Re: Groundwater Conceptual Site Model Former Smurfit-Stone/Frenchtown Mill Site, Missoula County, Montana, Draft Version 3, Issued: June 26, 2020.

**Missoula Valley Water Quality District Comments on Groundwater Conceptual Site Model Former
Smurfit-Stone/Frenchtown Mill Site, Missoula County, Montana, Draft Version 3**

Fig. 1 GWIC hydrograph of County Well

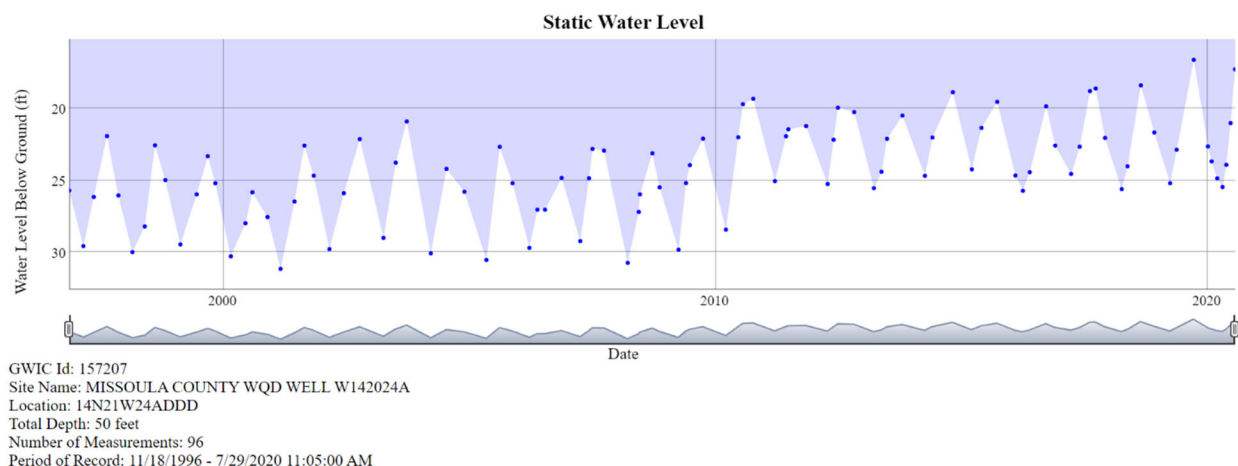
There is an obvious increasing trend in groundwater elevation at the nearby Water Quality District well (Fig. 1). Pumping seems to have impacted the well prior to 2010 so an increase in peak and minimum water elevations would be expected. After 2010, low water elevations appear to be consistent but peak water levels appear to increase. Are peak water elevations increasing across the site? Are they increasing in areas near waste basins and sludge ponds? This well is characterized as being in Unit 1 but the most recent swing in groundwater from peak flow in 2019 at 16.62 ft depth to water and low water in 2020 at 25.46 ft depth to water is difference of 8.83 ft. Is the characterization of Unit 1 fluctuation of two to seven feet only for wells onsite or should it be expanded to two to 8.8 feet?

Fig. 2 Forsland 2020 figure showing distribution of groundwater discharge zones on the Clark Fork River proximal to the Site.

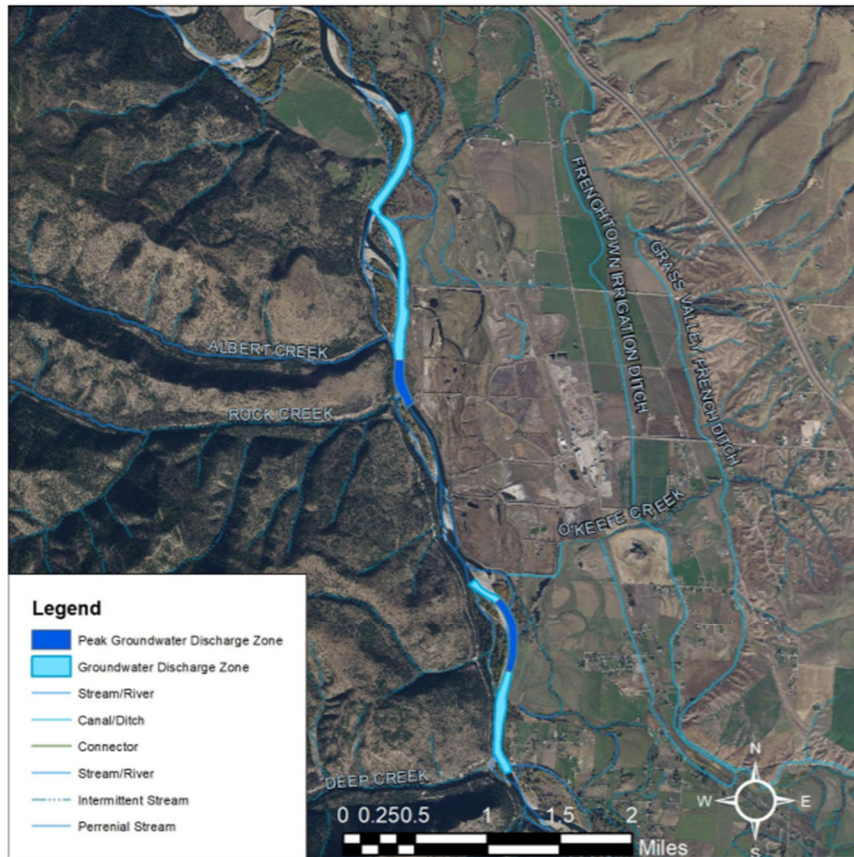
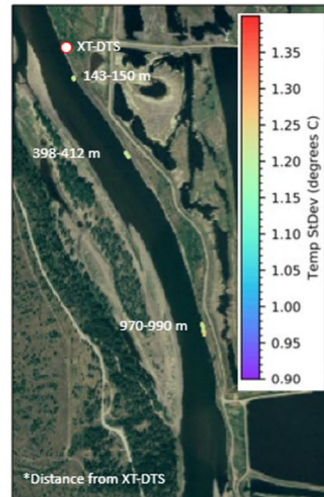
Citing one study from 1988 inaccurately portrays the current understanding of surface – groundwater interaction with the CFR in the Missoula Valley. See Forsland 2020 for review of current surface – groundwater studies on the Clark Fork River. In 2019, the University of Montana used collected water samples along the thalweg of the Clark For River to analyze radon decay and identify areas of groundwater discharge. Figure 11 from Forsland 2020 is revealing in demonstrating the variable nature of groundwater contributions to the Clark Fork River upstream, adjacent, and downstream of the Site. Review of this work, and other recent studies, should aid in determining whether surface water samples collected and discussed within the CSM are representative of the Site and improve selection of future surface water sampling locations.

Fig. 3 Maps from Silixa presentation to WQAC January 2020 showing areas where groundwater signals were identified using distributed temperature sensing.

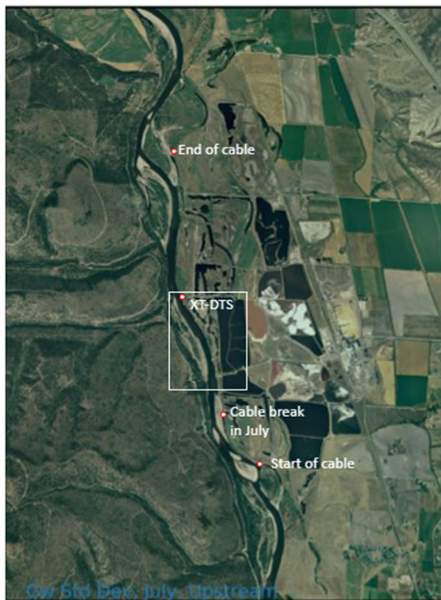
In a complementary study to Forsland 2020, the Missoula Valley Water Quality District worked with Silixa, a distributed temperature sensing company, to instrument a majority of the boundary of the site with fiber optic cable in order to conduct distributed temperature sensing and evaluate areas of likely groundwater contribution from the site to the CFR. This technology relies upon the refraction of the laser signal to identify changes in temperature. Groundwater has a consistent temperature and so when compared to the diurnal variation in surface water can be used to identify localized groundwater inflow. Figure 3 shows maps presented at the publicly noticed January Water Quality Advisory Council meeting, demonstrating where groundwater inflow was found at approximately one foot below water in late summer 2019 adjacent to the fiber-optic cable. These areas are ideal locations to collect surface water samples to identify water quality impacts from the Site on surface water.

17-D

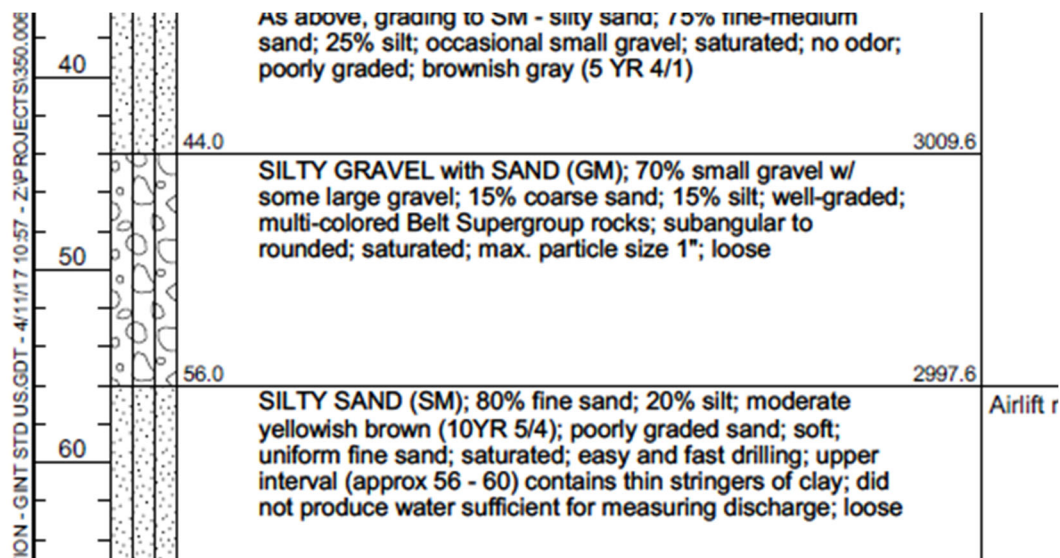
Relying upon a computer program to create cross sections and identifying pre-determined hydrologic units obscures available information and does not add to the current understanding of the site. These same cross sections should be done by a geologist with all available data. This is overly simplified to the detriment of understanding available site data. All well logs within the CSM are not included here and should be. All well logs should also be provided to the GWIC well log system.
